SAUNDERS SUBDIVISION, RESUBDIVISION OF LOT 1

Engineering Comments: FINAL PLAT COMMENTS (should be addressed prior to submitting the FINAL PLAT for review and/or signature by the City Engineer):

APPLICATION NUMBER 6 DATE March 1, 2018

DETAIL SITE PLAN

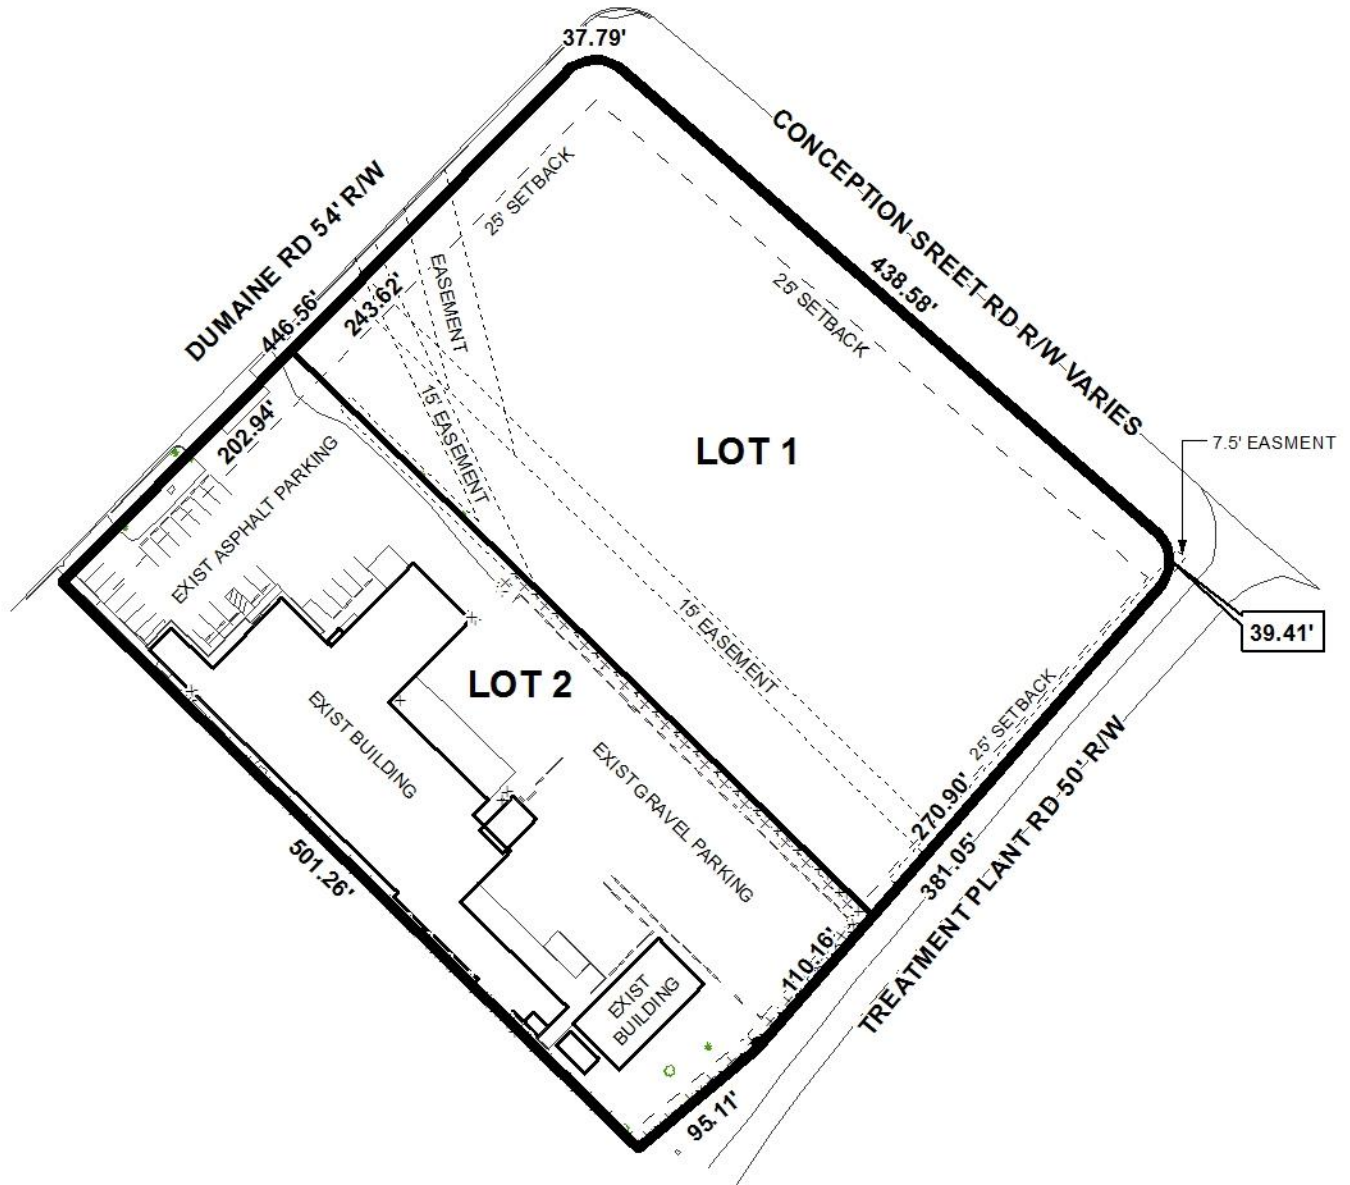
- B. Show and label all flood zones.
- C. Show and label the MFFE (Minimum Finished Floor Elevation) on each lot that contains an AE, V, or X (shaded) flood zone designation.

Traffic Engineering Comments: Lot 1 is limited to one curb cut to Dumaine Road and two curb cuts to Conception Street Road. Lot 2 lot is limited to two curb cuts to Dumaine Road. Access to Treatment Plant Road is denied until such time that the roadway is improved to City standards. Driveway size, location and design to be approved by Traffic Engineering and conform to AASHTO standards. Any new on-site parking, including ADA handicap spaces, shall meet the minimum standards as defined in Section 64-6 of the City's Zoning Ordinance.

Proposed Lot 1 has frontage on Conception Street Road, a proposed major street with a 100' right-of-way per the recently adopted Major Street Plan, and both proposed lots have frontages on Dumaine Road and Treatment Plant Road, both minor streets. Dumaine Road is equipped with curb and gutter and, as such, requires a 50' right-of-way; and, Treatment Plant Road is substandard from Conception Street Road to its paved portion, 575'± to the West.

Adequate right-of-way is illustrated along Dumaine Road and should be retained on the Final Plat, if approved. Inadequate right-of-way, however, is illustrated along Treatment Plant Road and Conception Street Road has no indication that the existing right-of-way width is reflected from the previous subdivision plat recorded in 2007. While previous subdivision of the site waived dedication requirements for the right-of-way along Treatment Plant Road because it terminated West of the site, it does appear that was because the substandard connection was to be utilized. As such, dedication should now be required to provide 30' from the centerline of Treatment Plant Road. Also, previous subdivision of the site required dedication of 50' from the centerline of Conception Street Road, thus the plat should be revised to illustrate the existing 50' from the centerline of Conception Street Road.

Because the Treatment Plant Road connection is substandard, a note should be placed on the Final Plat stating there shall be no future subdivision of the site until that portion of Treatment Plant Road abutting the site is improved in width and paved in asphalt to Engineering and Traffic Engineering standards.

Both proposed lots meet the minimum size requirements for lots served by public utilities and are illustrated in both square feet and acres. This information should be retained on the Final Plat, if approved, adjusted for any required dedication; or, provision of a table on the Final Plat providing the same information may suffice.

The 25' minimum building setback line is illustrated along all street frontages and should be retained on the Final Plat, if approved, adjusted for any required dedications.

Access management along Conception Street Road is a concern due to its status as a planned major street. Nevertheless, per Traffic Engineering comments, a note should be placed on the Final Plat stating that Lot 1 is limited to one (1) curb cut to Dumaine Road and two (2) curb cuts to Conception Street Road; that Lot 2 is limited to two (2) curb cuts to Dumaine Road; that access to Treatment Plant Road is denied until such time that the roadway is improved to City standards; and, that any changes to the sizes, locations or designs of all curb cuts are to be approved by Traffic Engineering and conform to AASHTO standards.
